FISH PASSAGE CENTER

MEMORANDUM

RE: Grant County performance testing in 2015

Figure 1. Statistical power to detect a difference between ‘fish mode’ on and off survival as a function of sample size. An equal sample size for each group is assumed. Each colored curve represents the difference between 95% ‘fish mode’ on and ‘fish mode’ off survival.

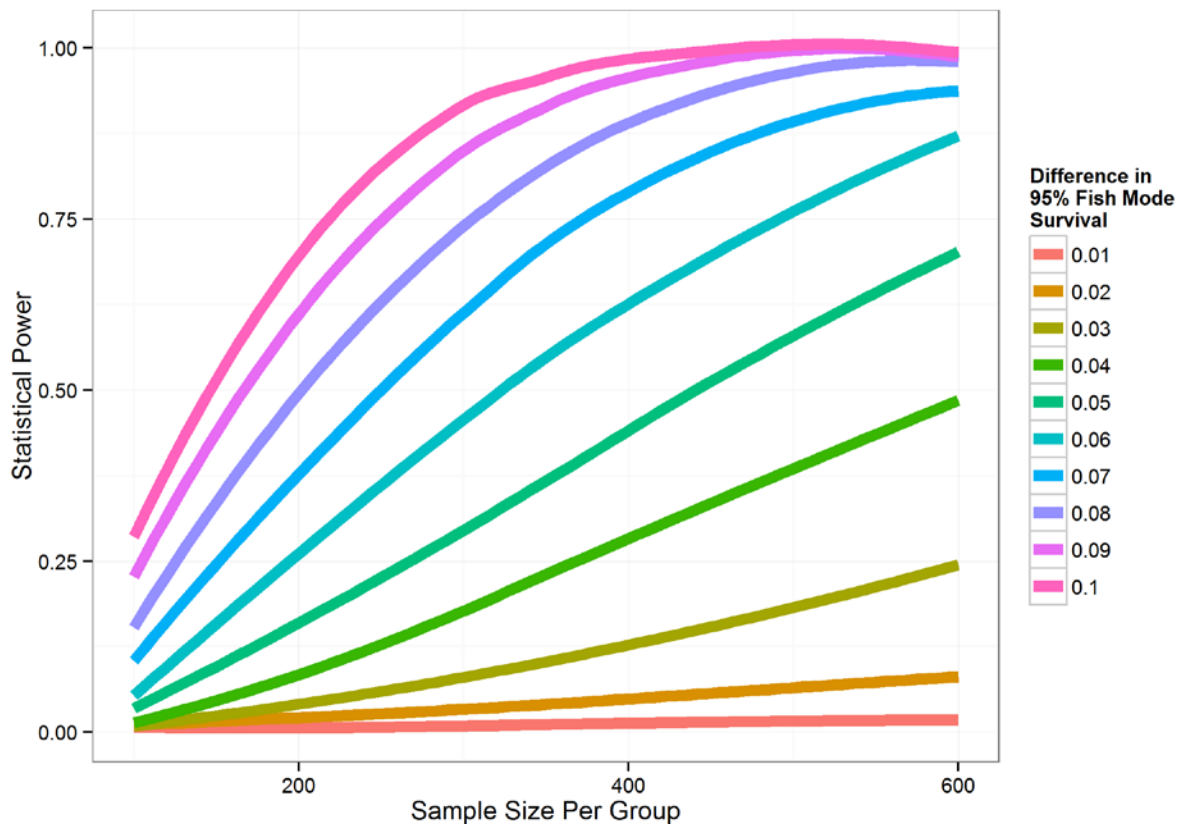
Figure 1 shows the results of the power analysis over a range of sample sizes for each 'fish mode' off treatment operation. Different curves are drawn for the assumed difference in powerhouse survival between the 'fish mode' on and off operations. Several conclusions can be drawn from this figure:

- Under the expected sample size of 170 individuals per ‘fish mode’ on and off treatment, the power to detect a statistical difference in survival rates ranged from < 1% to 62%. Statistical power was greater than 50% only when the difference in treatments was 0.1 (i.e., 0.85 ‘fish mode’ off turbine survival). All other differences in survival at these sample sizes resulted in statistical power less than 50%. For small differences in turbine survival, 0.01 – 0.04 (i.e., 0.91 to 0.94 ‘fish mode’ off survival), statistical power was less than 25%.

- Although the choice is arbitrary, a target of 80% statistical power is a commonly chosen target. Under the assumptions of our power analysis, 80% or greater statistical power is achieved only for very large differences in turbine treatment survivals, 0.07 – 0.1 (i.e., 0.85 – 0.88 ‘fish mode’ off survival). Additionally, 80% or greater statistical power is only achieved when the sample size is at least 250 fish under any assumed difference in turbine treatment operations.

- For more reasonable effect sizes, 0.01 – 0.04 (i.e., 0.91 to 0.94 ‘fish mode’ off survival), statistical power is always less than 50% even at the largest sample size of 600 individuals per turbine treatment operation.
